STATE OF NORTH CAROLINA
DEPARTMENT OF TRANSPORTATION

Subject: Modification Request for the Individual Section 404 Permit, Individual Water Quality Certification, and Tar-Pamilico Buffer Authorization for the Rocky Mount Northern Connector, from SR 1604 (Hunter Hill Road) to US 301, Nash County, TIP No. R-2823, Debit \$570 from WBS 34509.1.1.

In an application dated December 17, 2008, the North Carolina Department of Transportation (NCDOT) submitted an Individual Permit application for the Subject project. This application requested authorization for impacts to jurisdictional features based upon a final design prior to an additional public meeting presenting the final design, held on October 28, 2008. Based upon comments from the meeting and subsequent inquiries from the public concerning the traffic flow from Station -L- 27+45 to Station 65+55, the roadway was re-designed to include directional crossovers and four bulb U-turns to provide additional left-turn traffic flow along Woodruff Road. The redesign will result in unavoidable impacts to Waters of the U.S. Revised permit drawings, buffer drawings and roadway plans are included with this modification request.

REVISED 06/1/09
PERMIT DRAWING
SHEET 18 OF 68

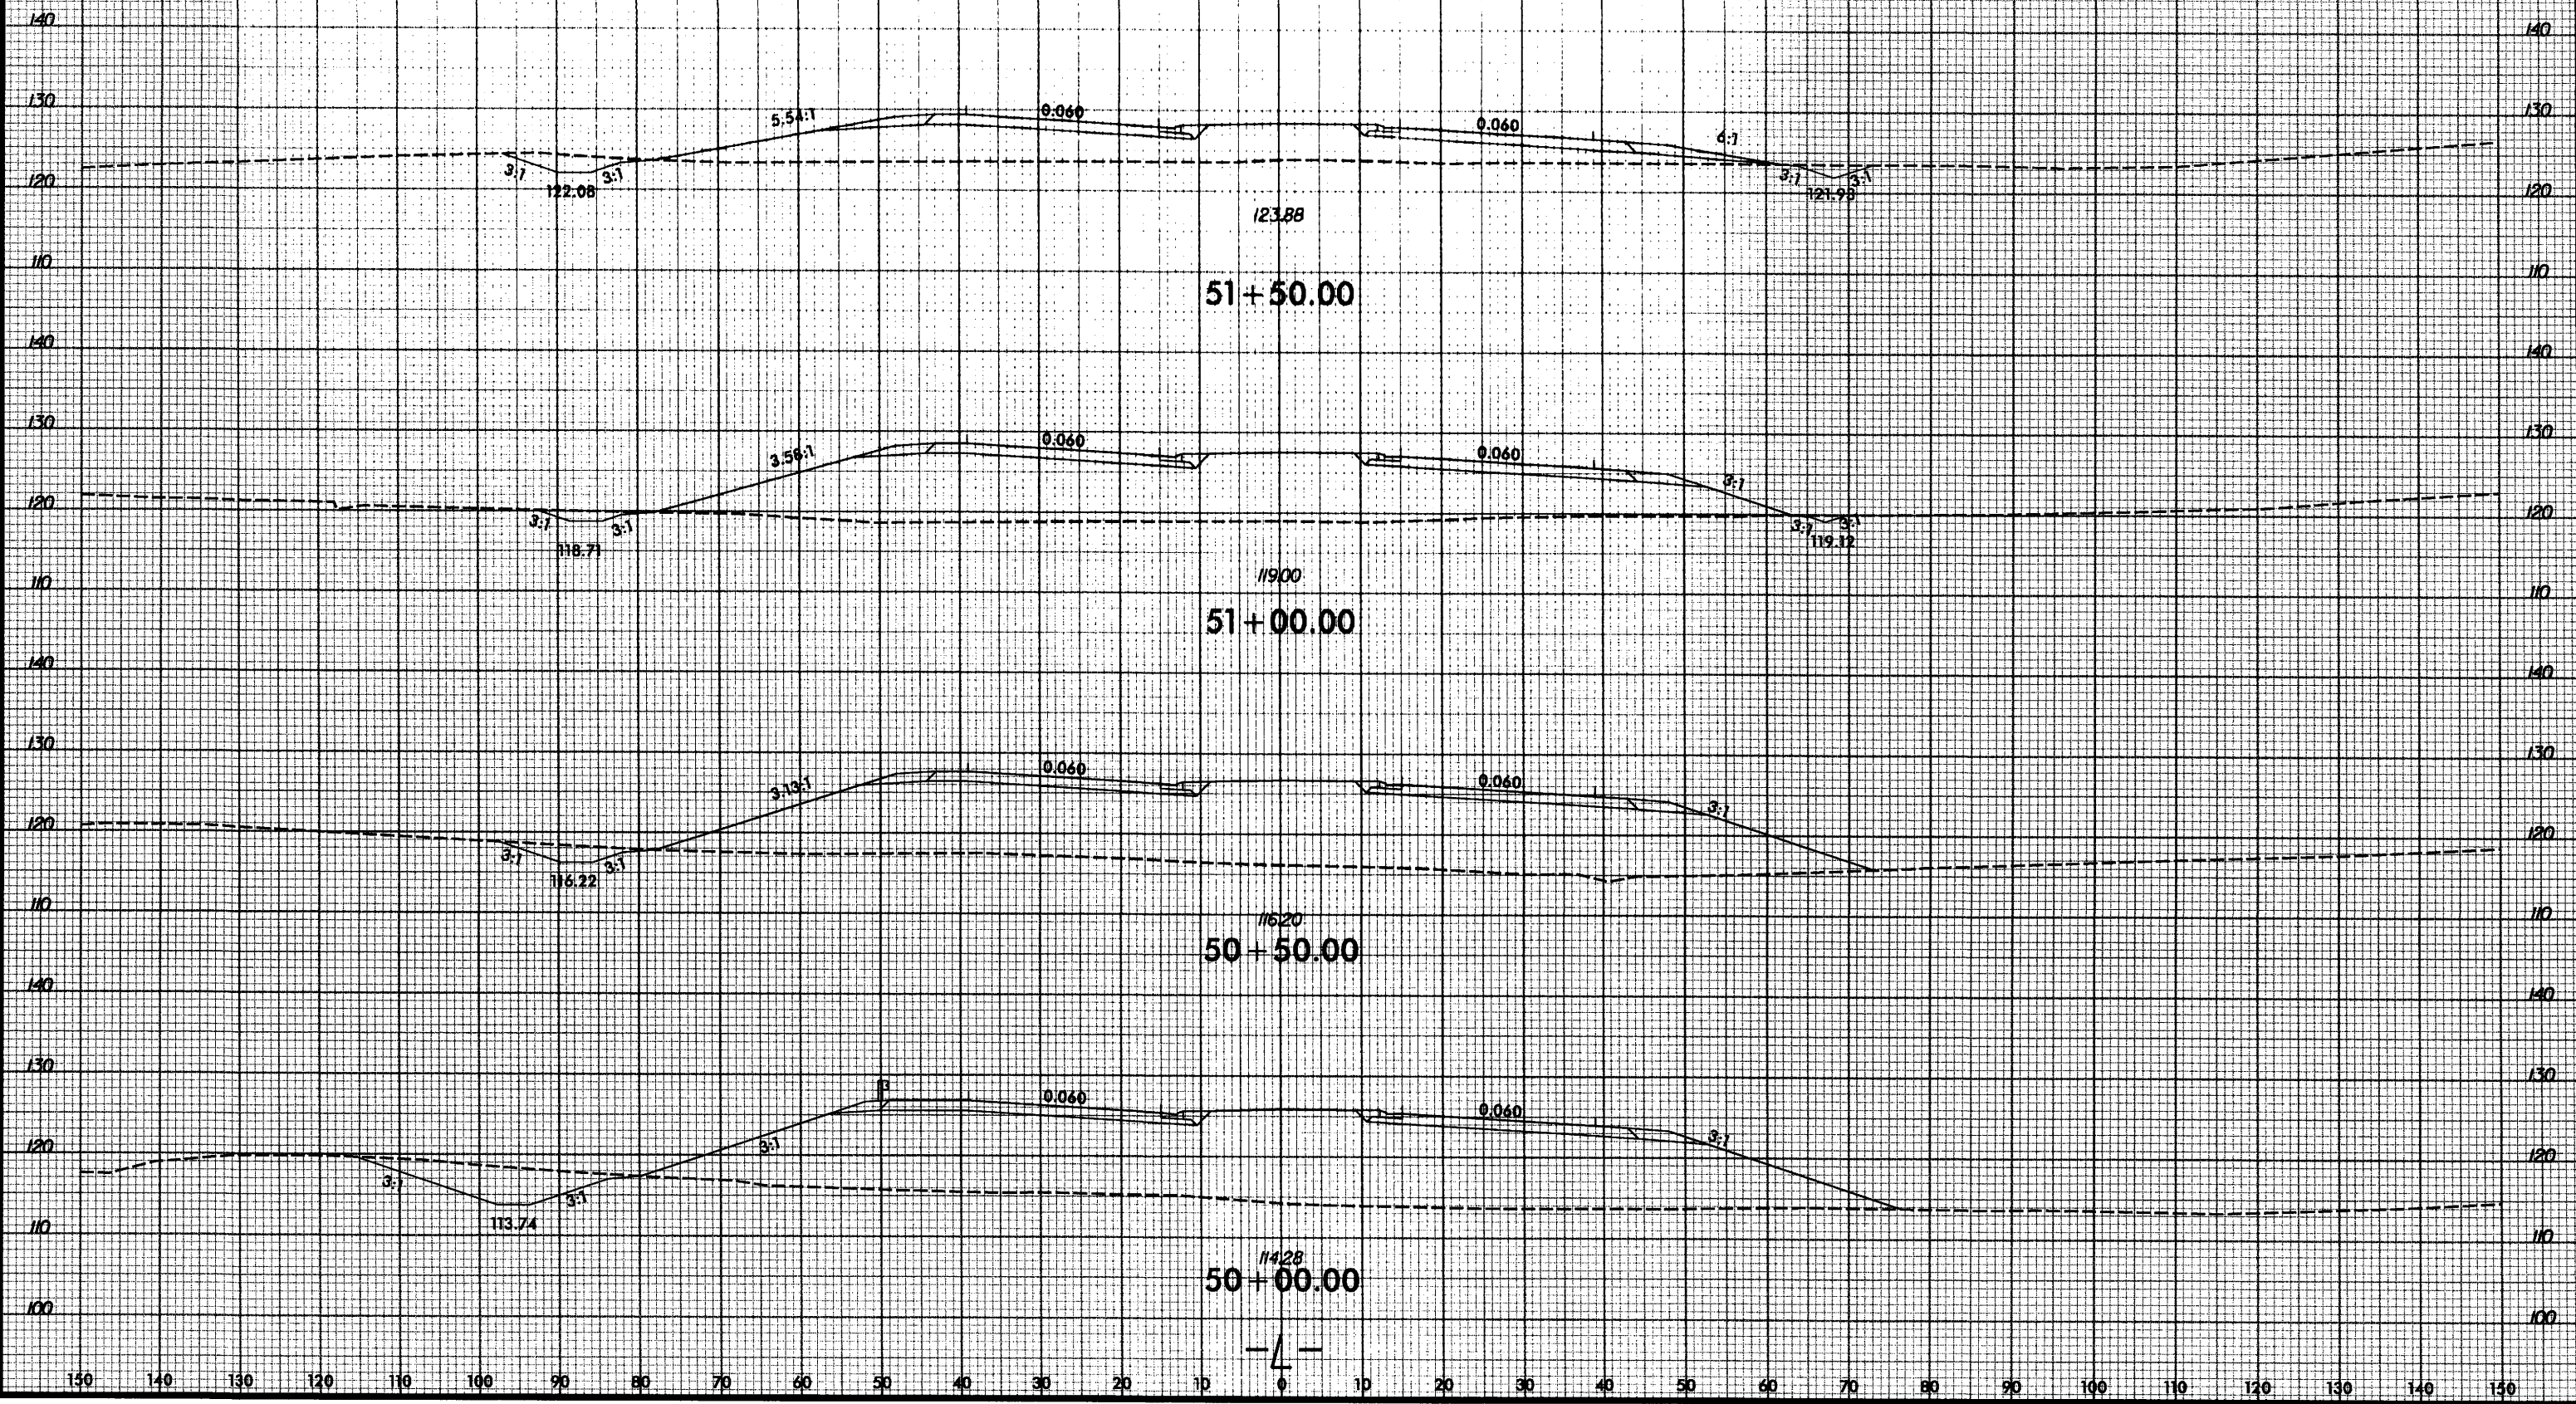
Revised profile and cross section permit sheets 16-18 of 68 (buffer sheets 17-19 of 56) are enclosed.

Revised cross section permit sheets 16-18 of 68 (buffer sheets 17-19 of 56) are enclosed.

PROJECT REFERENCE NO.		SHEET NO.	
R-2823		8	
RW SHEET NO.			
ROADWAY DESIGN ENGINEER		HYDRAULICS ENGINEER	
REVISED 06/11/09 PERMIT DRAWING SHEET 19		OF 68

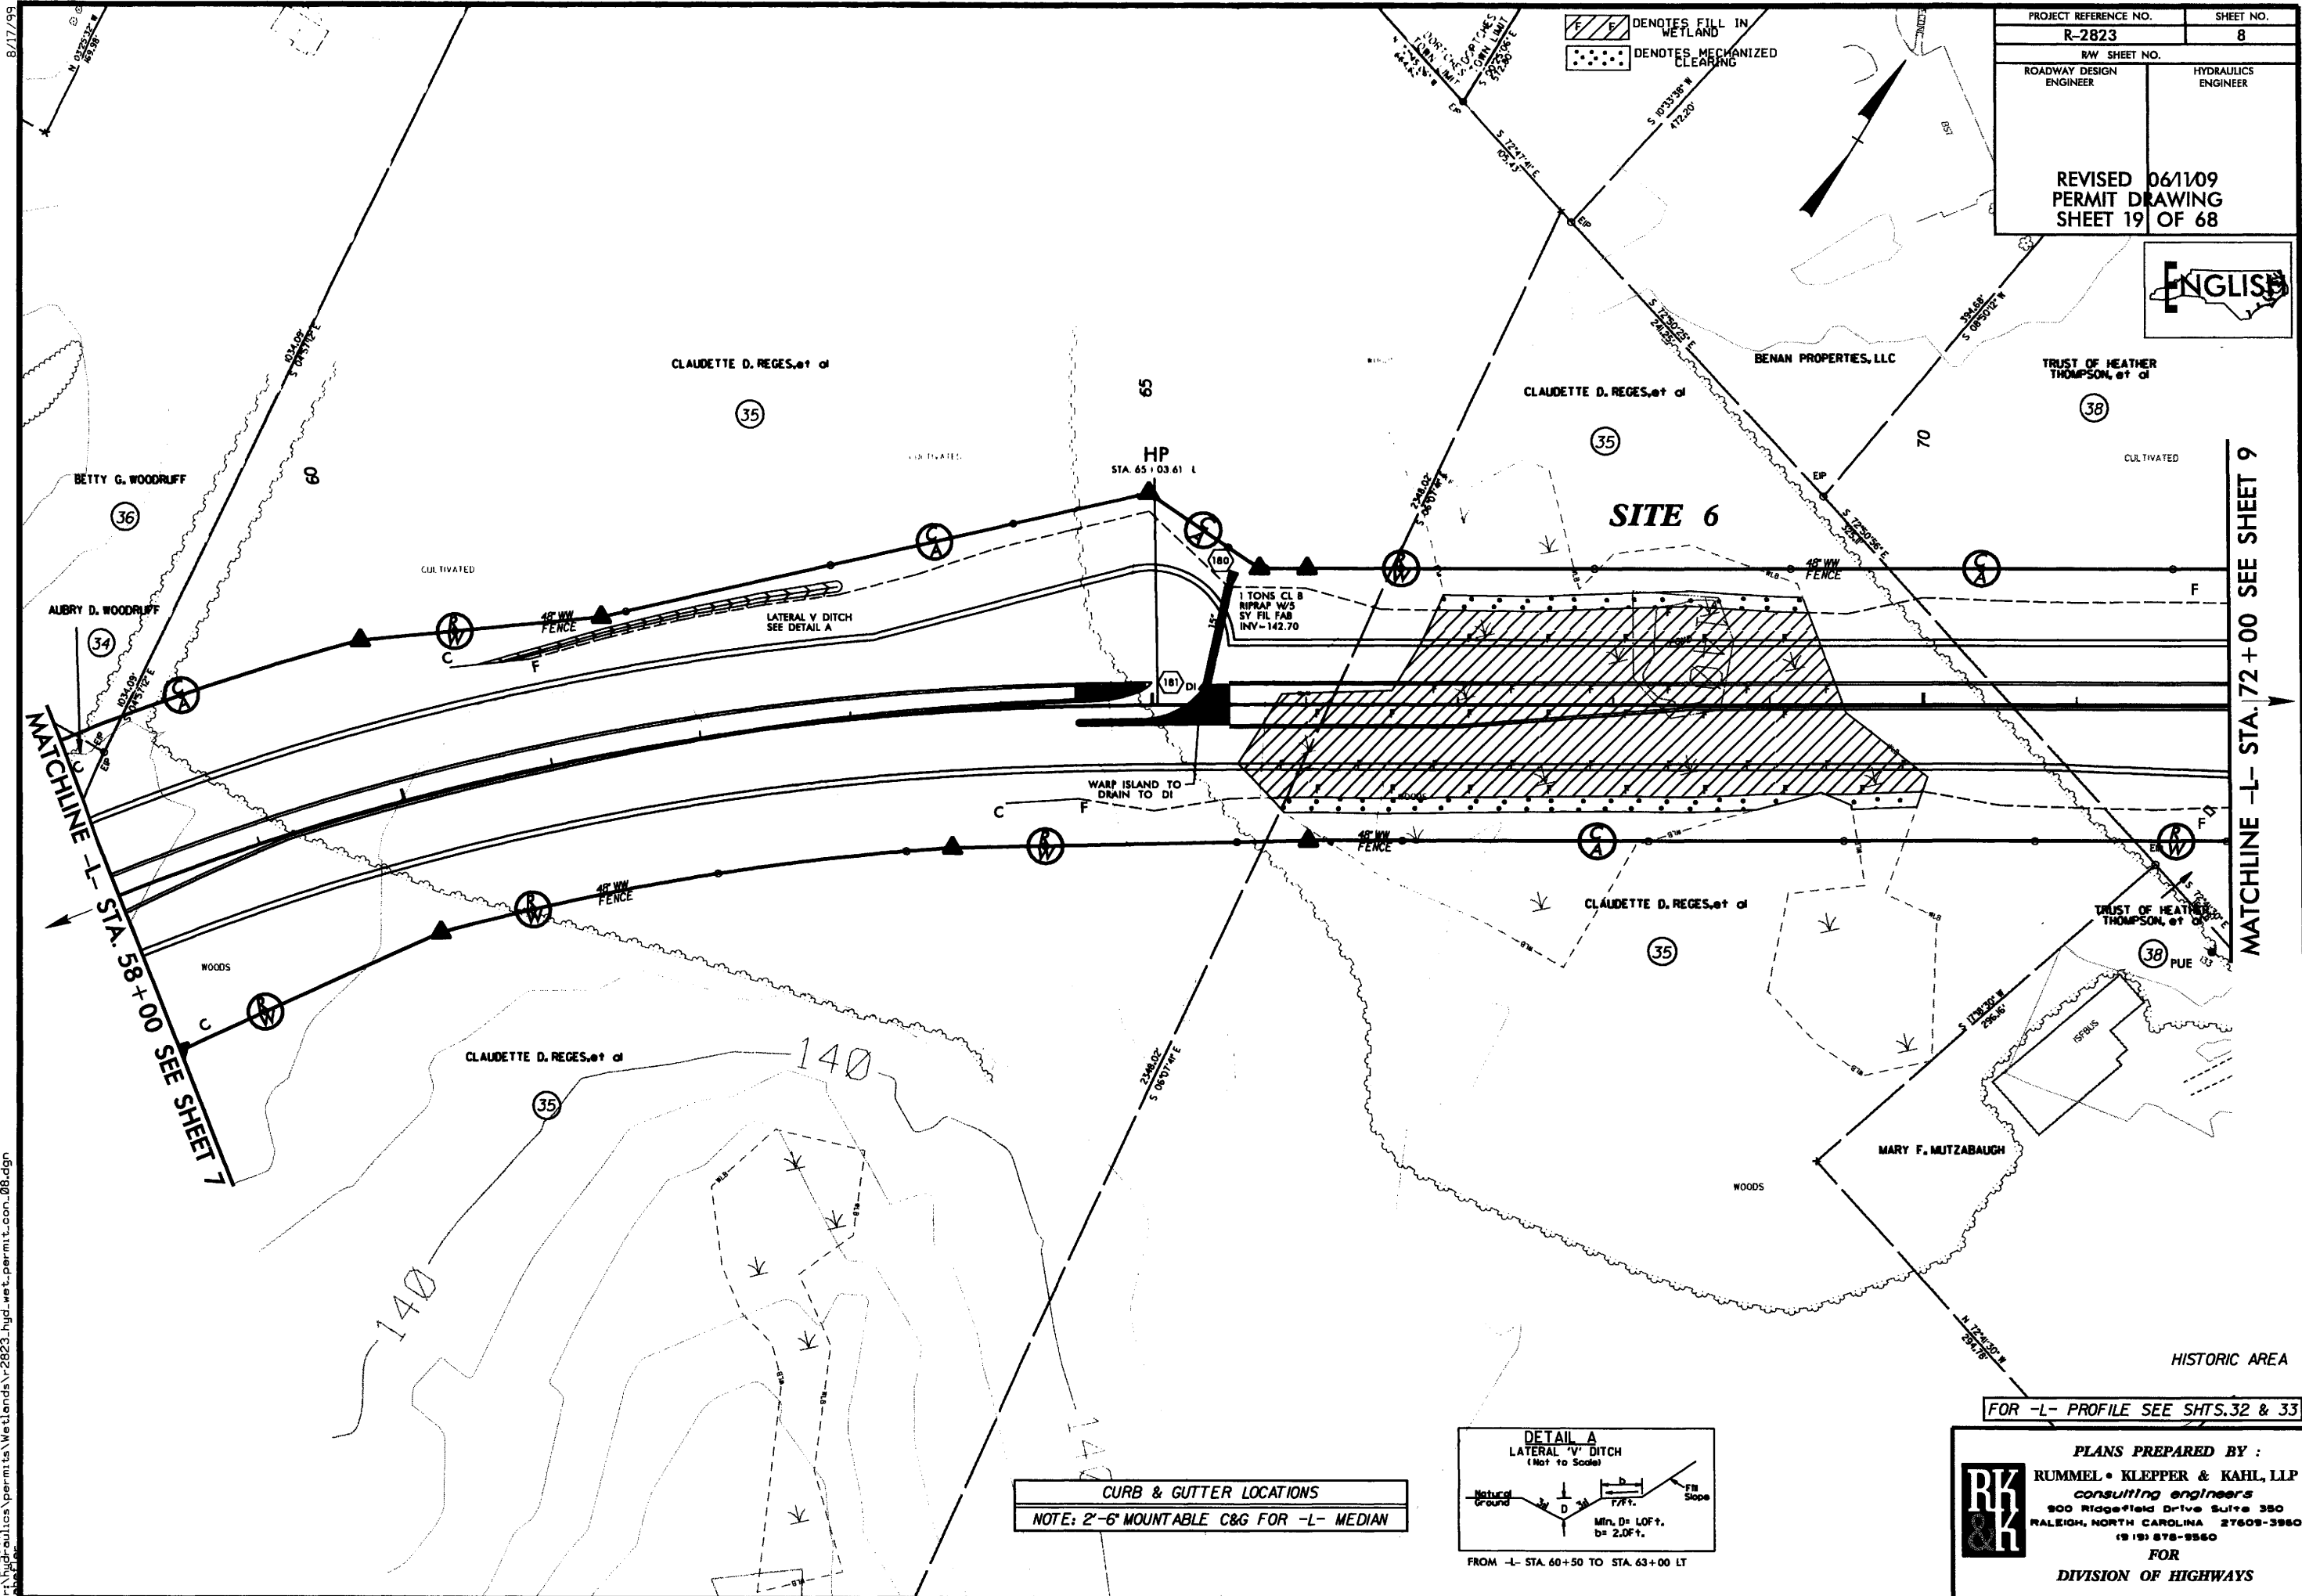
- Permit Drawing Sheets 19 and 20 of 68 show visual changes due to the addition of a bulb.
- Permit Drawing Sheets 62 and 63 of 68 have visual changes due to a couple new ditches required due to pipe clearance issues. (-L- Sta. 261+22 - 263+01 RT and -Y8- Sta. 17+00 - 17+39 and 19+04 - 20+00 RT)
